Planning Commission Report

Site Plan, Preliminary, & Final Plat for 1665 Oakdale Ave – More Space LLC

Re: More Space Self Storage Stormwater Review
WSB Project No. 013770-000

Site Plan Review – More Space Self-Storage; Oakdale Avenue

Utility Plan

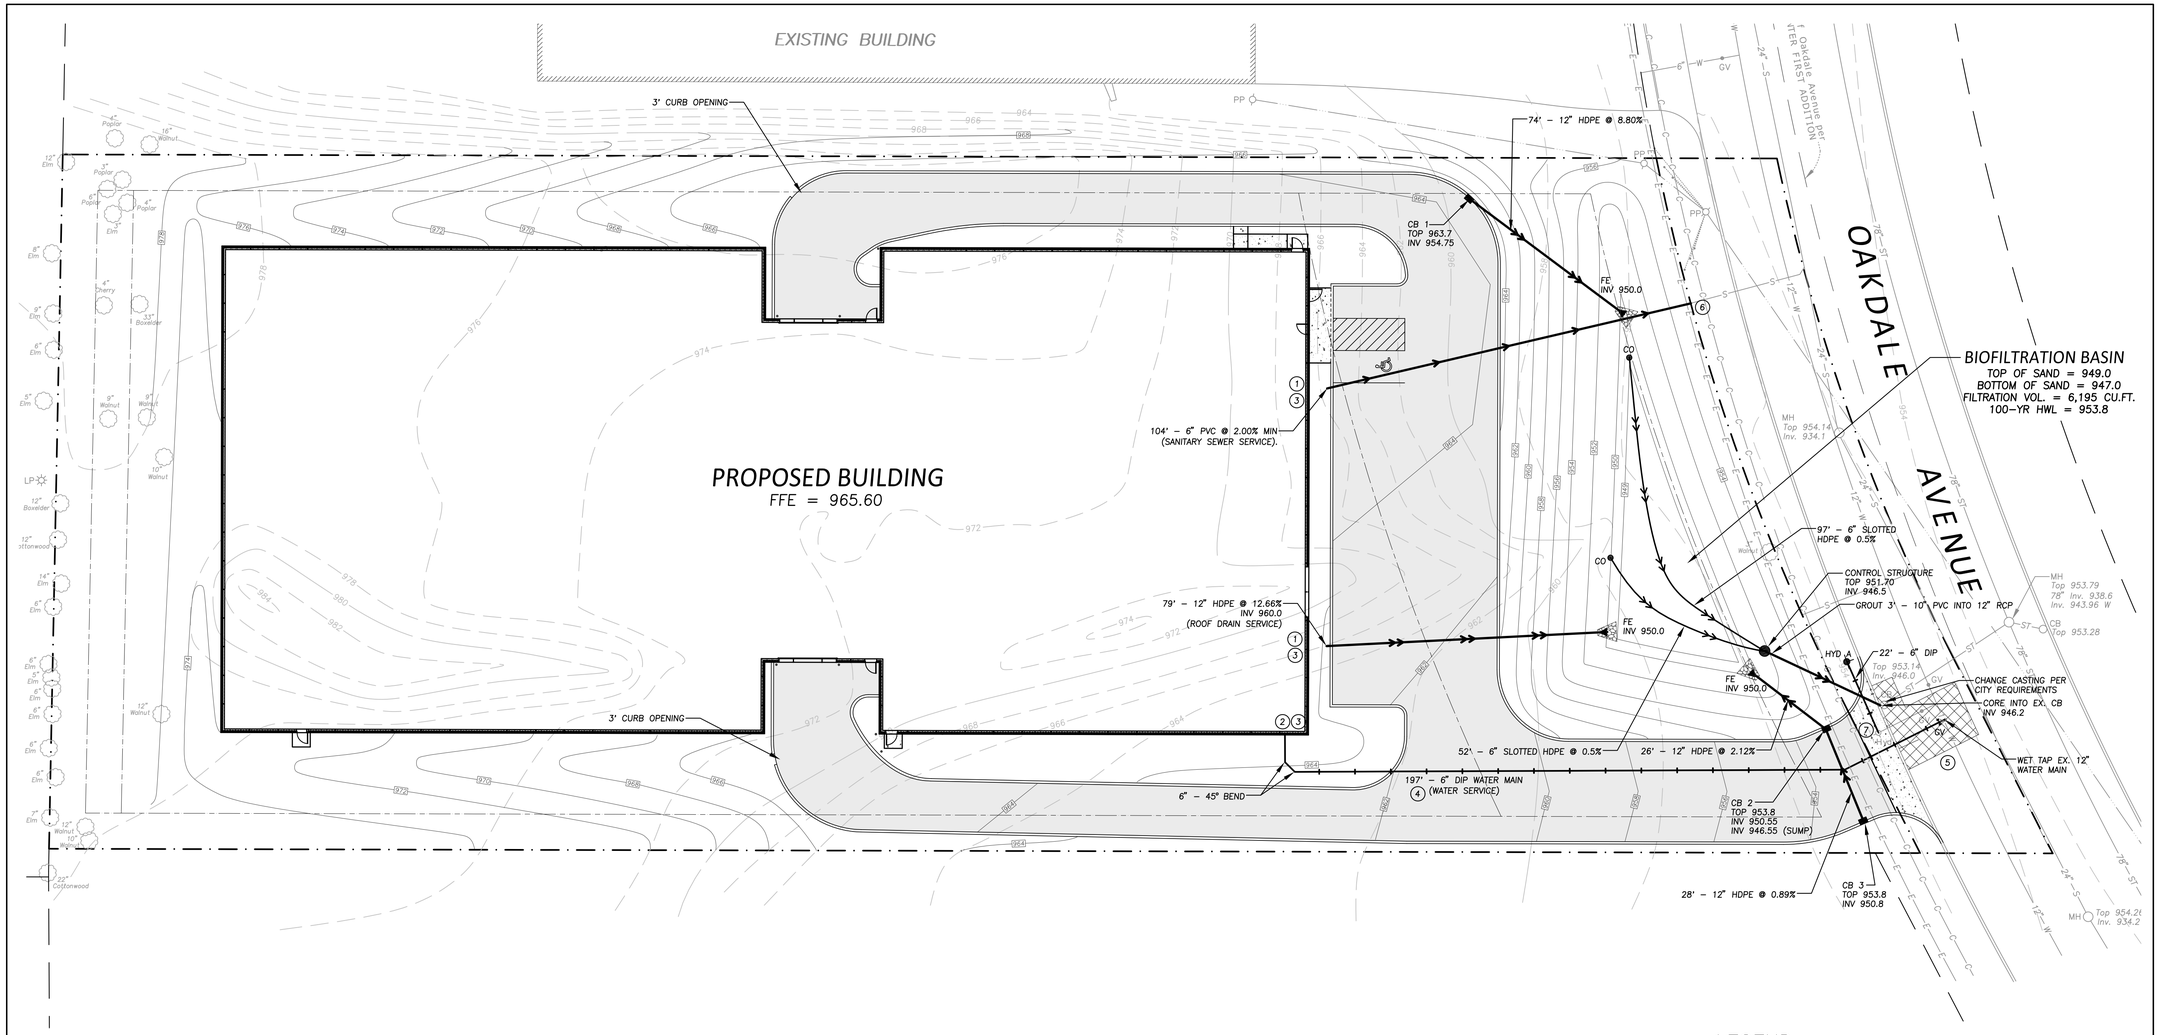
1. A callout should be added to the proposed pipe connecting into the catch basin along Oakdale Avenue to confirm its size, slope and material.
2. A sump should be added to CB 1 to provide pretreatment.
3. The elevation and location of the emergency overflow for the biofiltration basin should be added to the plan.
4. The corners of the bottom contours in the biofiltration basin should be smoothed out to make them constructible.
5. It is recommended additional storm sewer be added to pick up the runoff from the swales and route it to the biofiltration basin to reduce the amount of runoff running in the gutters.

Tree Preservation Plan

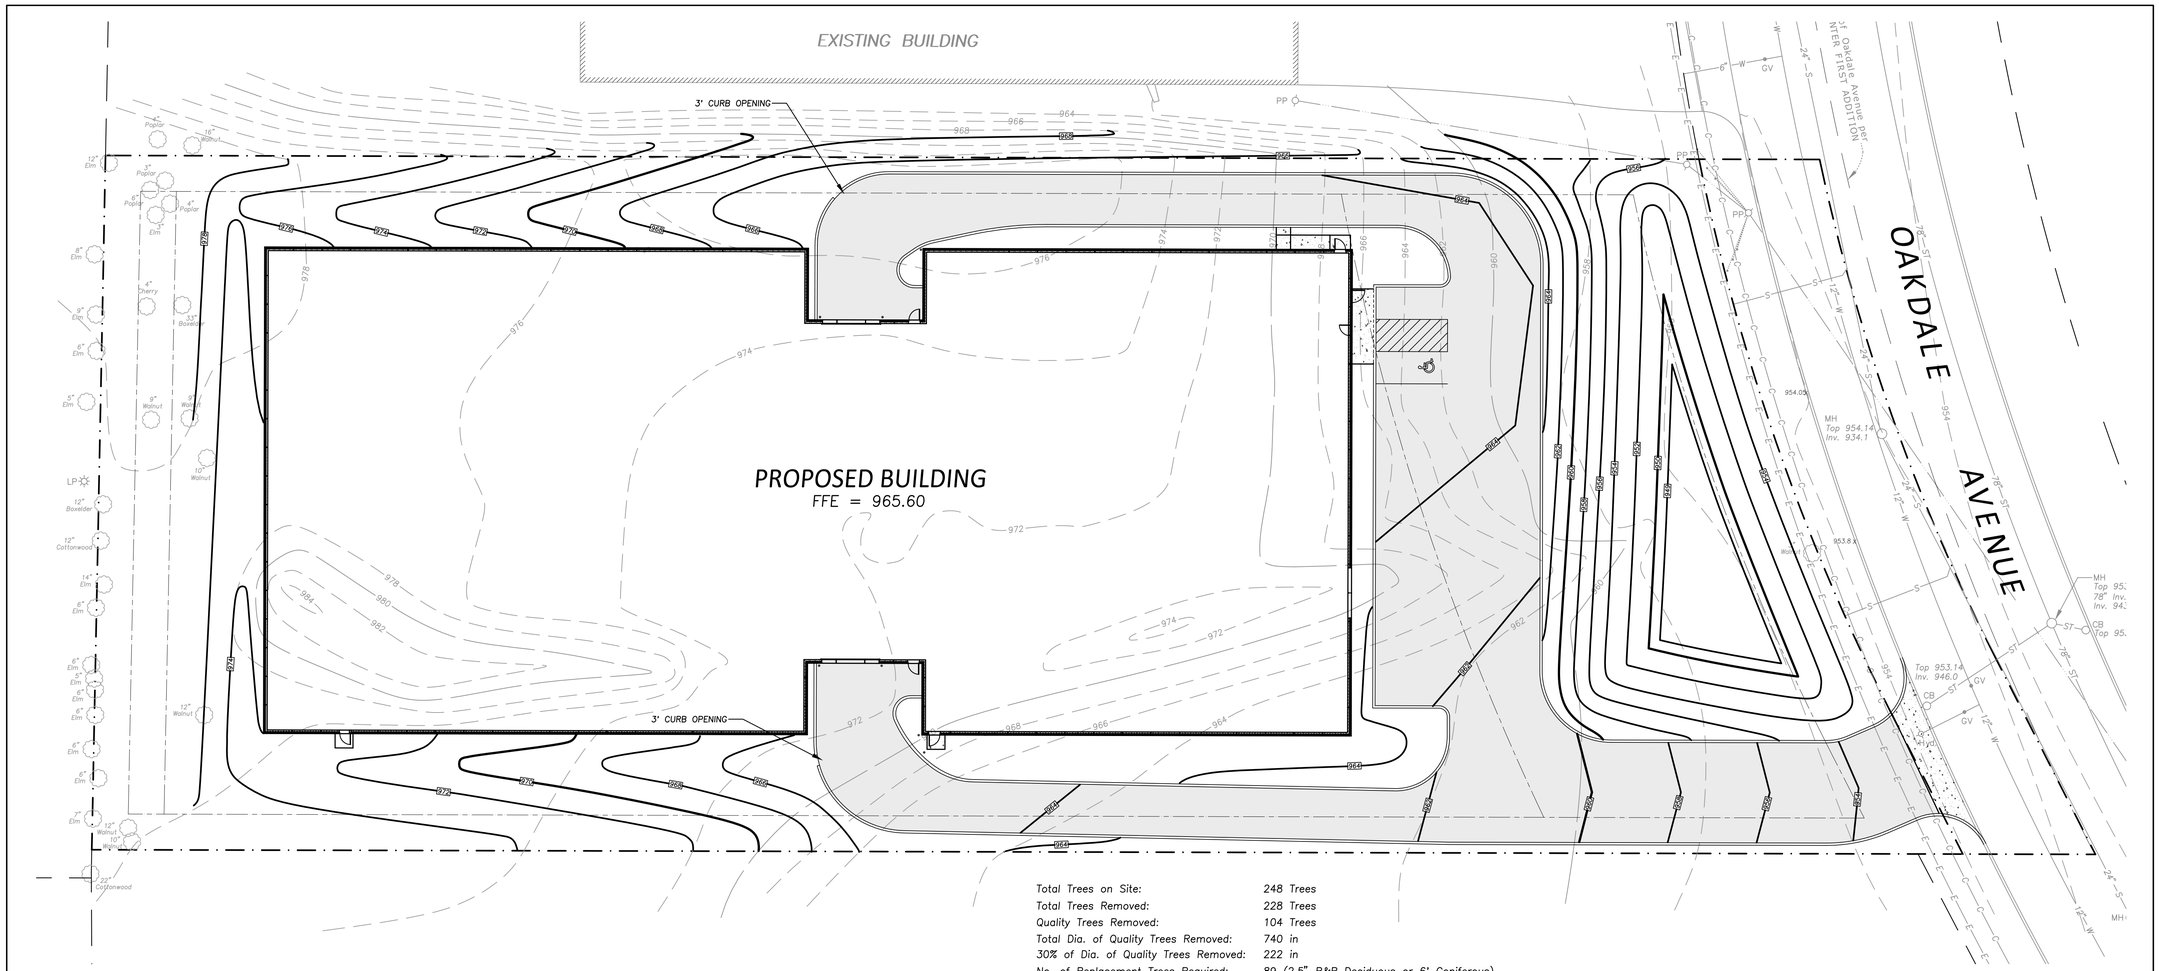
Landscaping
The submitted plans detail the removal of 104 quality trees (740 caliper inches). The zoning ordinance requires that whenever the removal of quality trees occurs, a minimum of 30 percent must be replaced. For the proposed removal, the required caliper inches to be replaced equates out to 222 caliper inches (or 89 trees that measure 2.5 caliper inches). The submitted plan numbers fall just short of the required minimum while proposing a total of 210 caliper inches (see landscape plan for specifics). As a result, City Staff is recommending as a condition of approval that the applicant either increase the number of trees or caliper inches of the proposed trees to meet the 222 caliper inches needed to meet the minimum.

4. The applicant revise plans to either increase the number of trees or increase the caliper inches of the proposed trees to meet the 222 caliper inches minimum requirement,

Landscape Plan

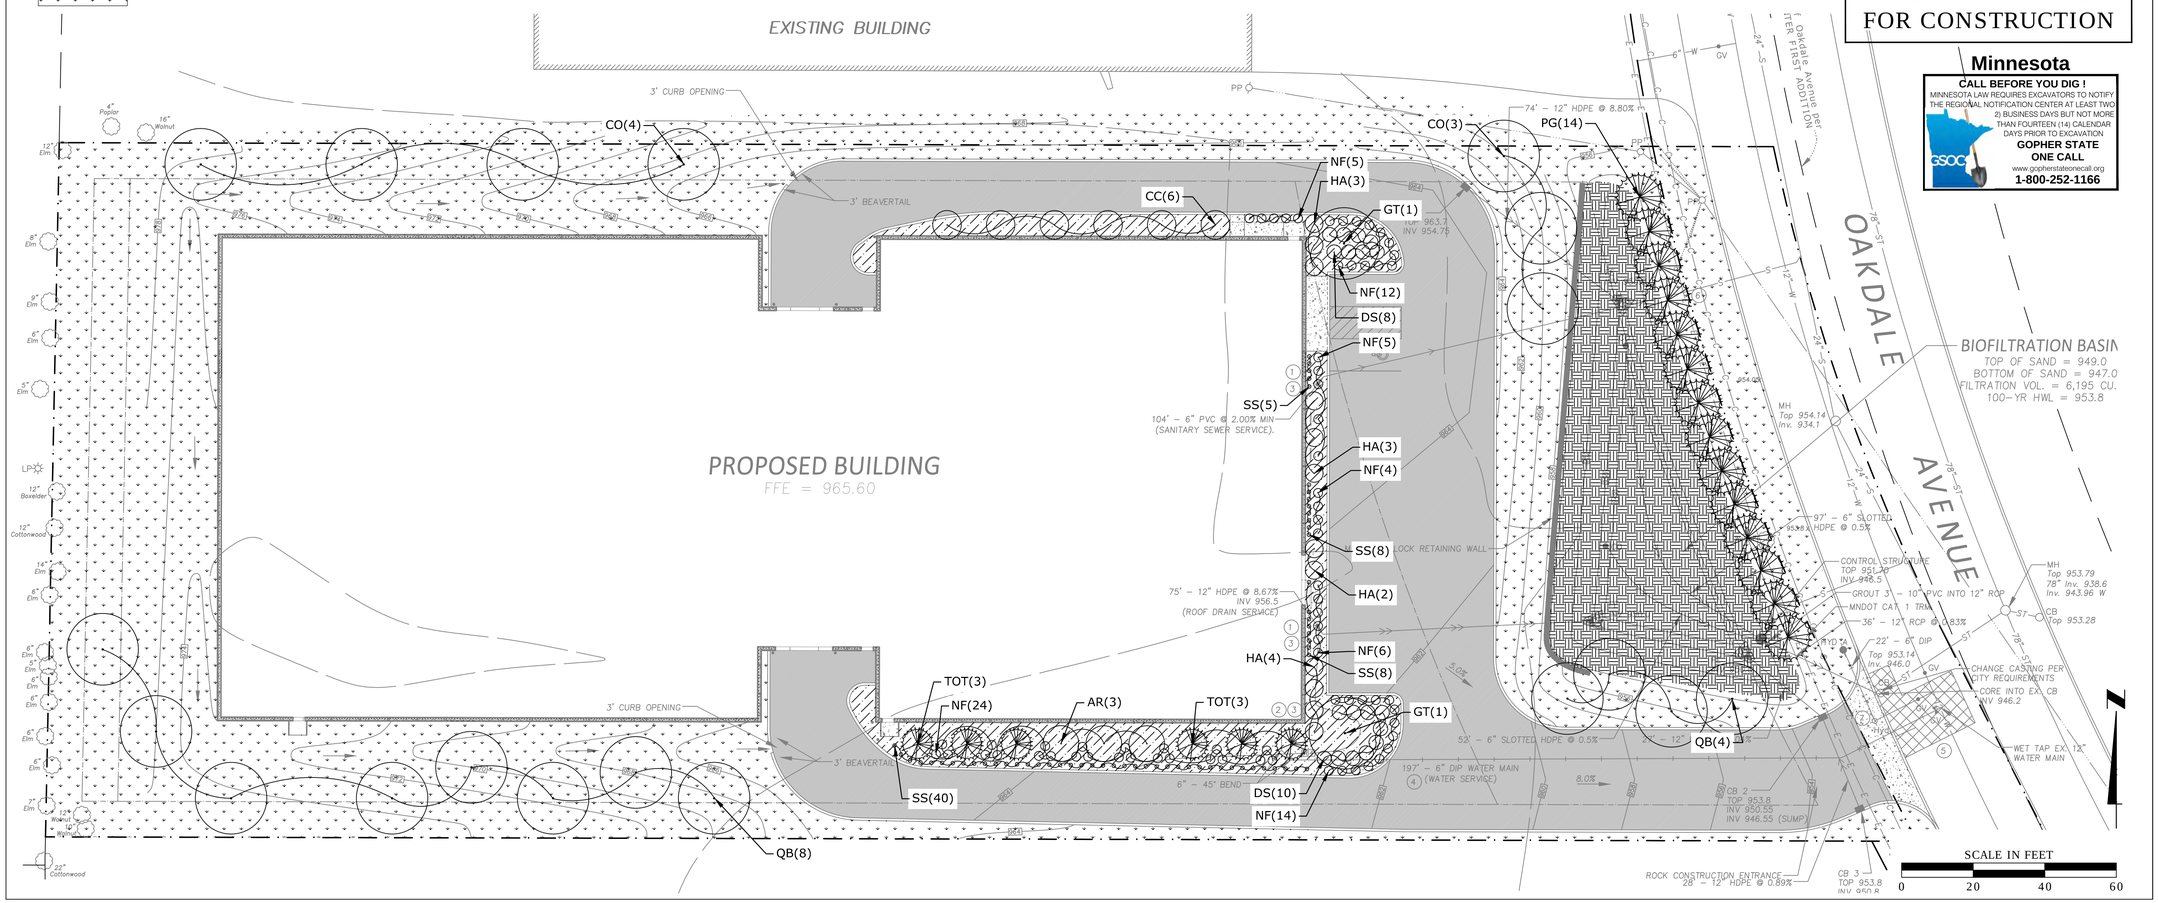
In addition, for development/redevelopment in commercial and industrial districts, the code requires one tree per 20 lineal ft. of property line, which for this property (1,398 lineal ft.) equates out to 70 trees. As shown in the attached plans, the applicant is proposing 50 deciduous trees, totaling to 210 caliper inches, as well as 30 shrubs, 70 perennials, and 61 ornamental grasses. Staff is comfortable with the lower number of trees since the proposed size of the trees is larger. Specifically the 14 evergreens located in the front yard that are expected to measure 30ft. in height.

Overall, Members liked the stormwater plan and the addition of the bio-retention pond, as well as the variety and selection of plantings. Members did not like the great loss of mature trees on the site and the fact that full required replacements are not being met, but understand there is limited space for new trees. Other comments by Members included the addition of Dark Sky compliant lighting, a green or white roof, and additional screening along Oakdale due to the destination park across the street.

- They strongly encourage the developer to use "pollinator friendly" native plants that were not treated with "neonicotinoids",
- The addition of a green roof to treat stormwater onsite or white roof to reduce urban heat island effect, and
- Strongly encourage all exterior lighting to be Dark Sky compliant.
